Bid Bulletin #03

PROJECT: Educare of Winnebago
Bid Package #04
Winnebago, NE

ADDENDUM H

Educare Winnebago
Winnebago, Nebraska
RDG Project No. 2010.175.00, File 35.1

2010.175.01
 45.2
 SDA-019

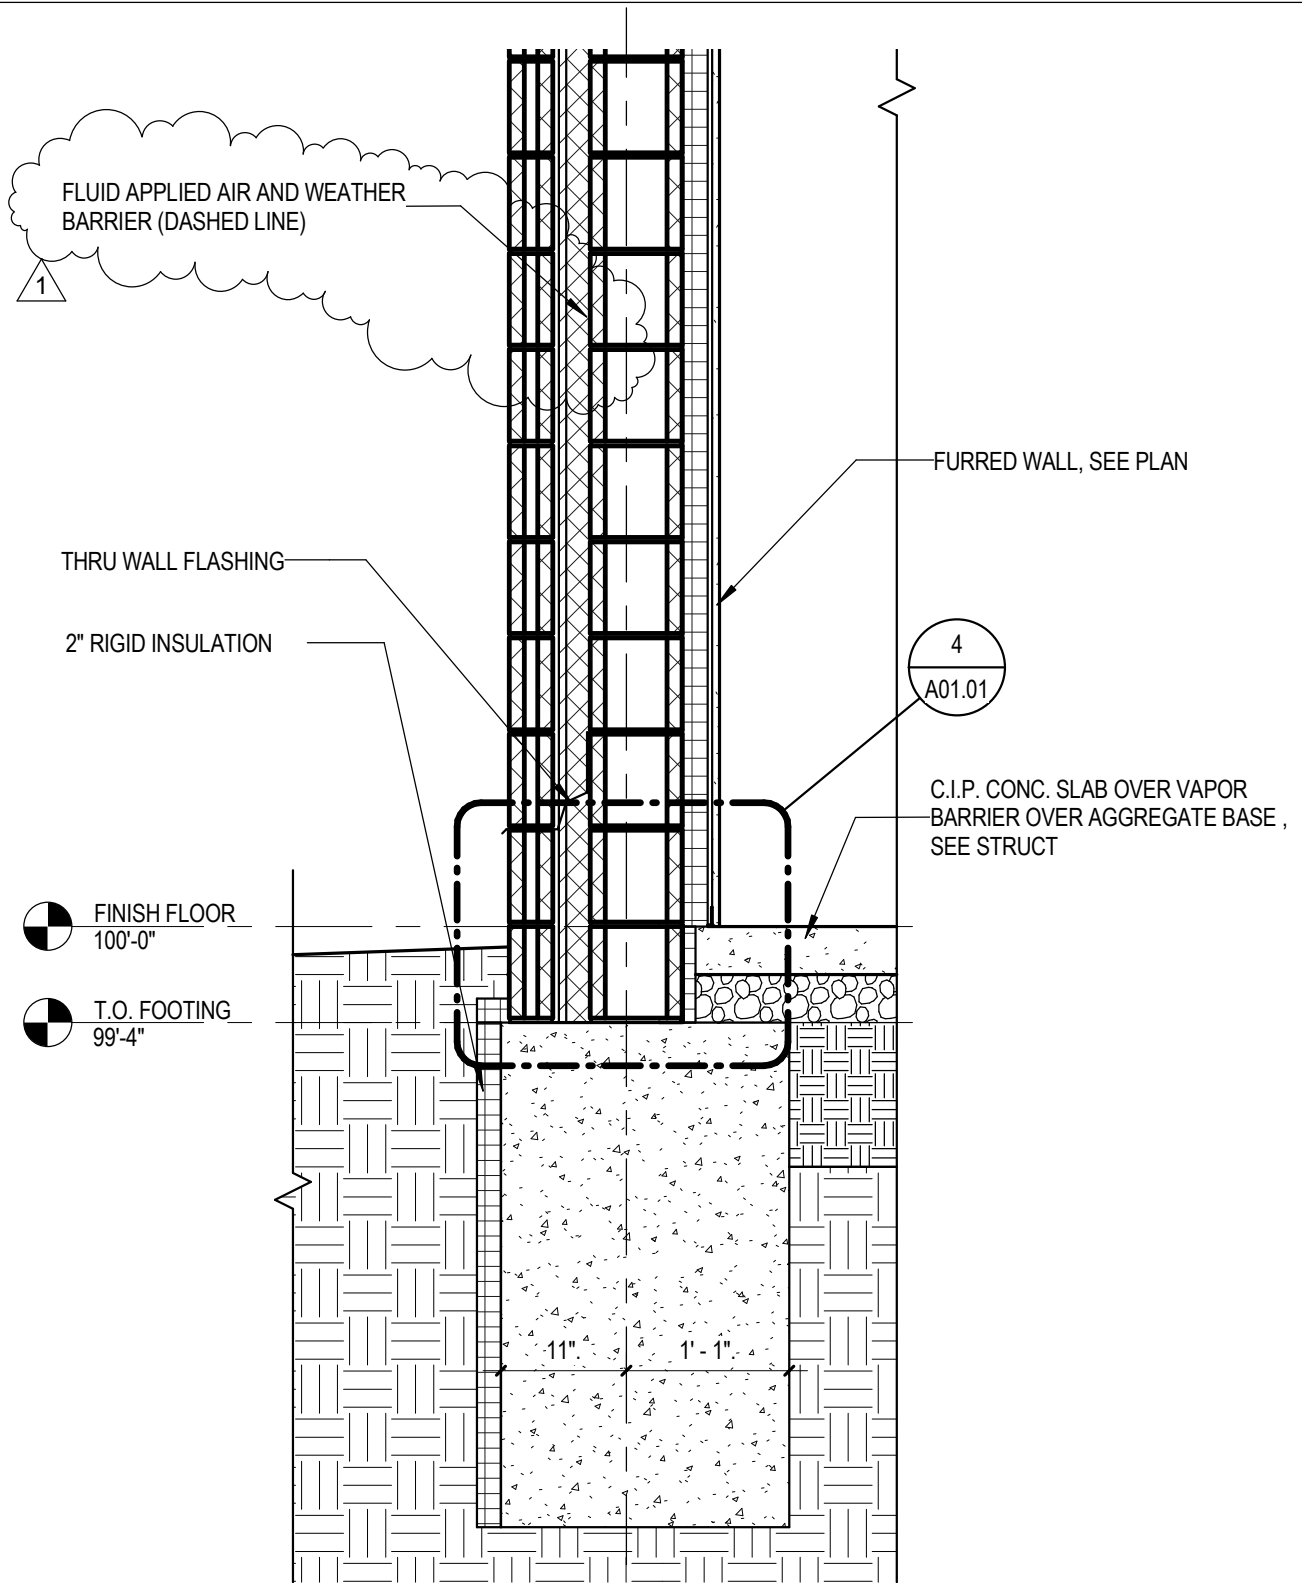
- A. Detail 72, 102B Jamb: Revise per attached Supplemental Drawing SDA-018.
- B. Detail 73, 102B Sill: Revise per attached Supplemental Drawing SDA-019.
- C. Detail 79, 102B Jamb: Delete detail.

2010.175.01
 45.2
SDA-020

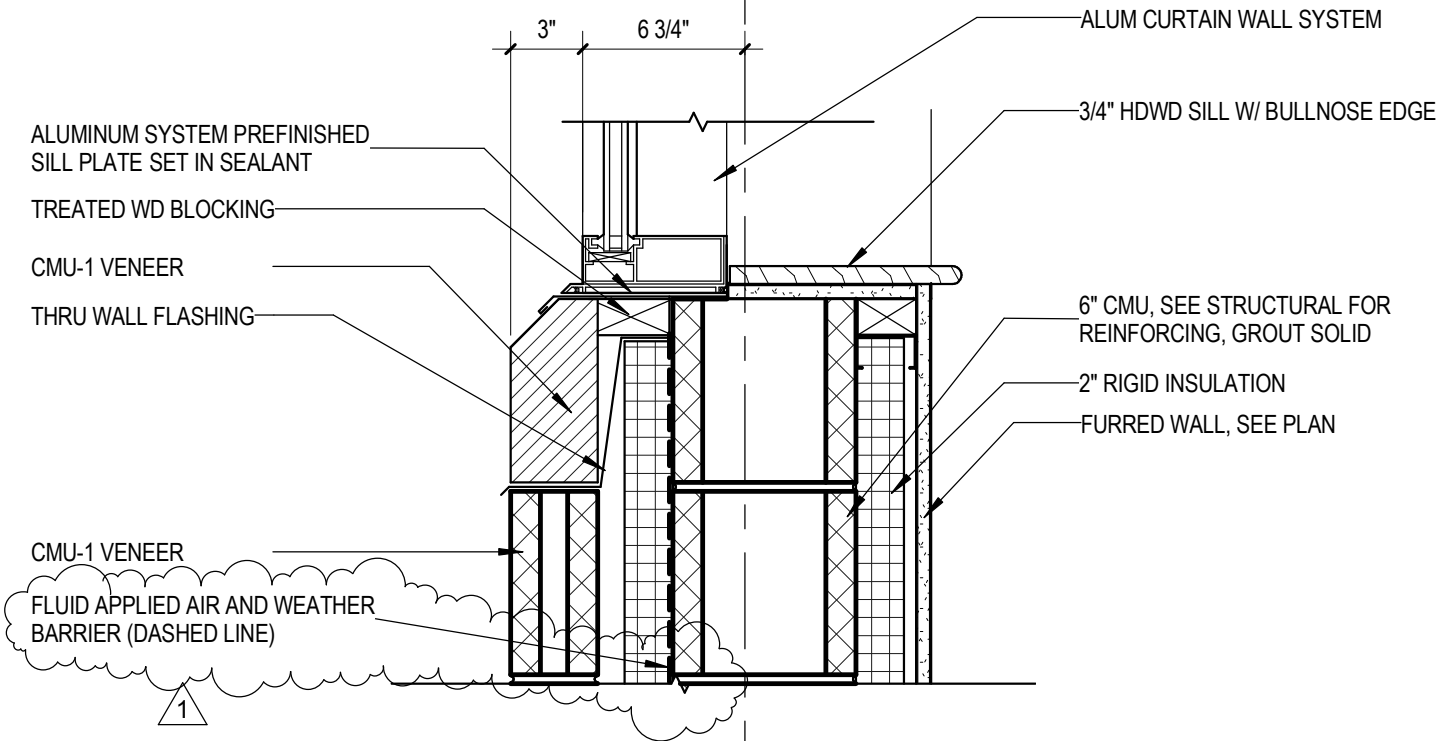
- A. Section 2: Add note reading **“FLUID APPLIED AIR AND WEATHER BARRIER”** to the outer face of the 8” structural CMU. See attached Supplemental Drawing SDA-020 for revision.
- B. Detail 7: Add note reading **“FLUID APPLIED AIR AND WEATHER BARRIER”** to the outer face of the 8” structural CMU. See attached Supplemental Drawing SDA-021 for revision.

2010.175.01
 45.2
SDA-022

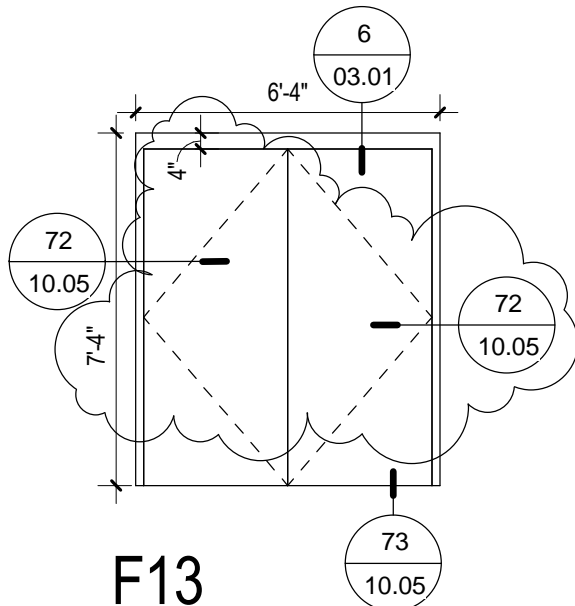
- A. Add note reading **“FLUID APPLIED AIR AND WEATHER BARRIER”** to the outer face of the 8” structural CMU. See attached Supplemental Drawing SDA-022 for revision.
- B. Revise configuration of thru-wall flashing. See attached Supplemental Drawing SDA-022 for revision.

2010.175.01
 45.2
SDA-023

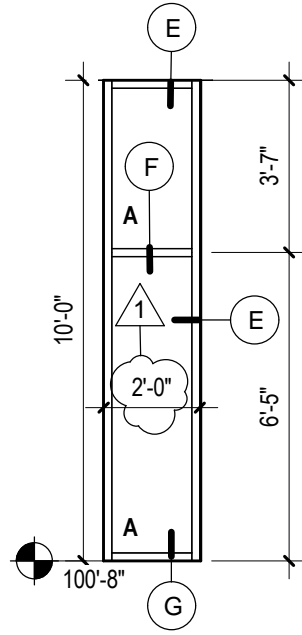
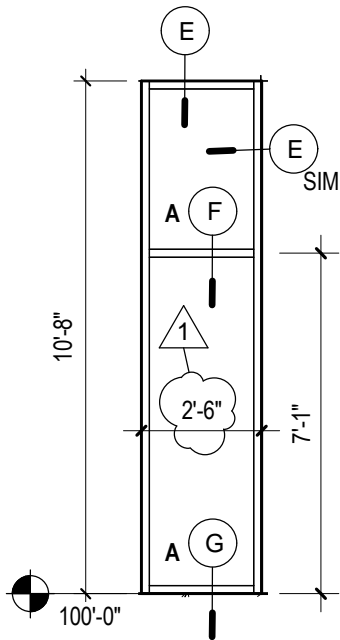
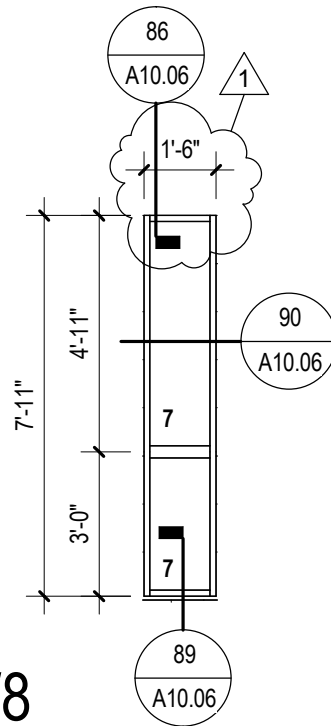
- A. Door Schedule:
 - 1. Door 102A.3: Revise height to read **7'-0.”**
 - 2. Door 102B.3: Revise height to read **7'-0.”**
- B. Frames:
 - 1. Frame Type F4:
 - a. Change Reference 79 / A10.05 to read **“73 / A10.05.”**
 - b. Change Reference 73 / A10.05 to read **“72 / A10.05.”**
 - 2. Frame Type F13: Change Reference 79 / A10.05 to read **“72 / A10.05.”** Update dimensions per attached Supplemental Drawing SDA-023.

3. Frame Type F17: Add dimensions per attached Supplemental Drawing SDA-023.
4. Frame Type F22: Add dimensions per attached Supplemental Drawing SDA-023.
5. Frame Type W8: Add dimensions per attached Supplemental Drawing SDA-023.

E00.01

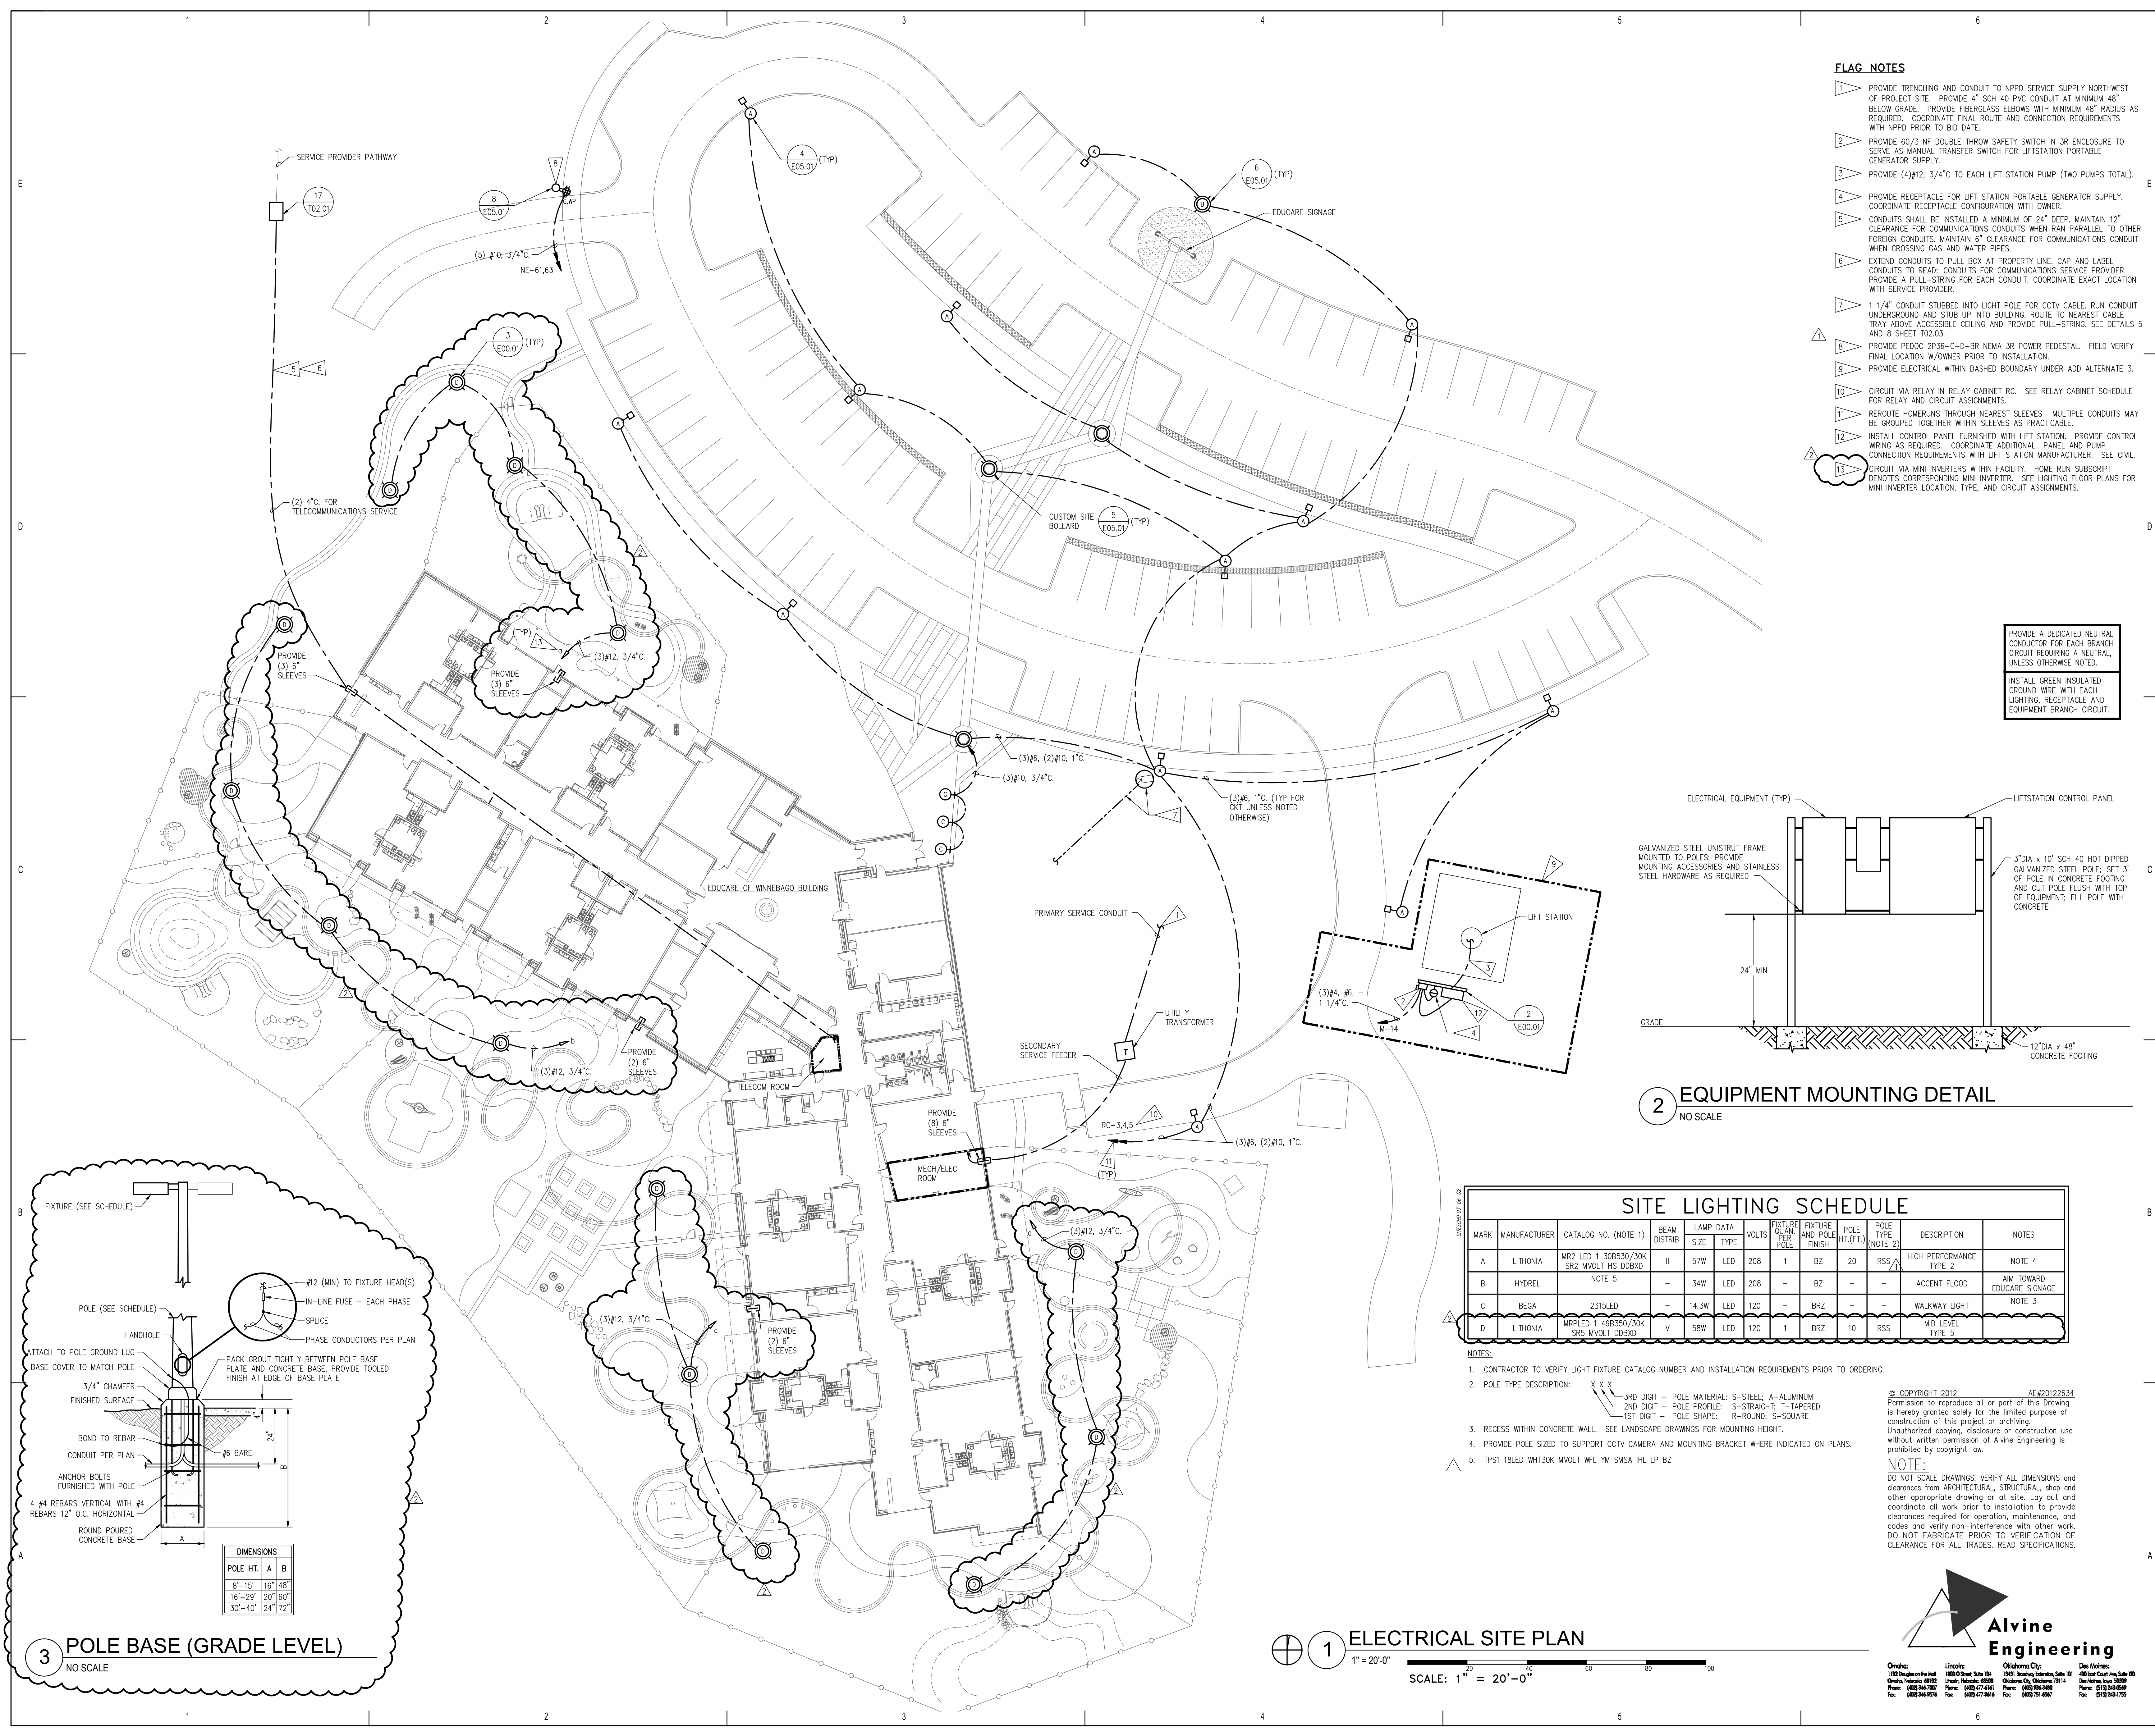
- P. Alternate No. 18– Additional Egress Site Lighting (Refer to Reissued Electrical Sheet E00.01 for Extent of Additional Lighting):*
 - 1. *Base Bid: Provide all previously-designed exterior site layout. The additional site lighting , associated circuiting, and rough-ins will not be provided.*
 - 2. *Add Alternate: Provide additional exterior pole lighting, infrastructure, and circuiting as defined on reissued Sheet E00.01.*

Sheet E00.01 – Electrical Site Plan, Add Alternate 18. Add exterior pole lighting and associated circuiting per attached Sheet E00.01.
